Contract #: 04-0120F4
 Cty: SF/ALA Rte: 80 PM: 13.2/13.9
 File #: 69.25B

QUALITY ASSURANCE -- NON-CONFORMANCE REPORT

Report No: NCR-000340

Reference Description: Missed UT indications by QC

WELD NUMBER: SEG032*-032

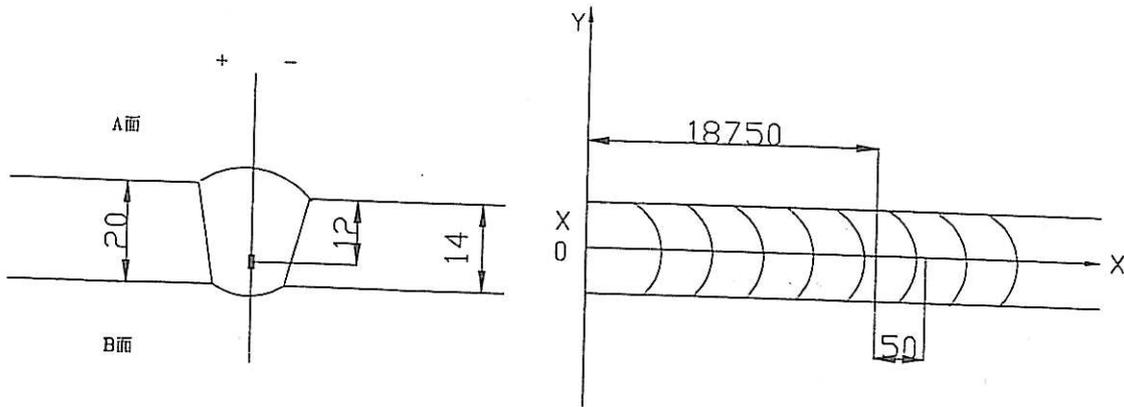
Rejected indication found by ultrasonic inspection is less than the maximum allowance aggregate length.

1. 焊道未及时处理干净。
1. Did not clear the weld pass completely in time.

1. 从缺陷距离端面较近一侧 ($D \leq 0.65T$, D为缺陷深度, T为板厚) 采用碳刨或打磨的方法去除焊缝缺陷;
 2. 参照返修焊接工艺规程 (WPS) 准备正确的接头型式, 预热和焊接;
 3. 焊前对修补区域进行VT检测保证缺陷完全被清除;
 4. 将修补区域打磨到与母材或邻近焊缝平齐;
 5. 根据批准的车间图纸检查焊缝.
-
1. Gouge or grind from nearer side from metal edge ($D \leq 0.65T$, "D" is depth of defects, "T" is thickness of metal) to remove all defects;
 2. Follow repair WPS for joint preparation, preheat, and weld deposit;
 3. Verify with VT no defects remain in the weld joint prior to welding;
 4. Grind the repaired area flush with base metal or the adjacent weld;
 5. Check the welds according to the working drawings.

1. Improve monitoring of welding and interpass cleaning.

(UT探伤发现的缺陷总长度小于最大允许长度。) SEG032K-005

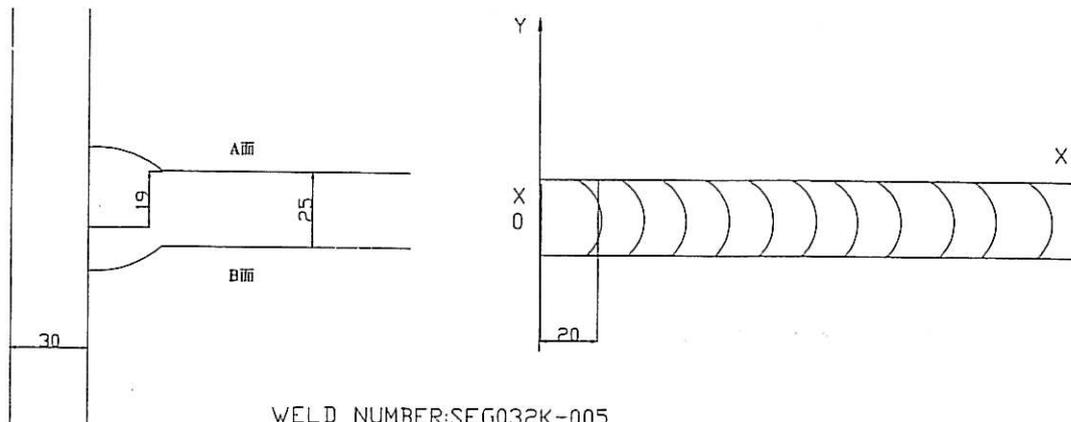
Rejected indication found by ultrasonic inspection is less than the maximum allowance aggregate length.

1. Did not clear the weld pass completely in time.

1. Gouge or grind from nearer side from metal edge ($D \leq 0.65T$, "D" is depth of defects, "T" is thickness of metal) to remove all defects;
2. Follow repair WPS for joint preparation, preheat, and weld deposit;
3. Verify with VT no defects remain in the weld joint prior to welding;
4. Grind the repaired area flush with base metal or the adjacent weld;
5. Check the welds according to the working drawings.

- 加强焊接监控和道间清理。
- Improve monitoring of welding and interpass cleaning.
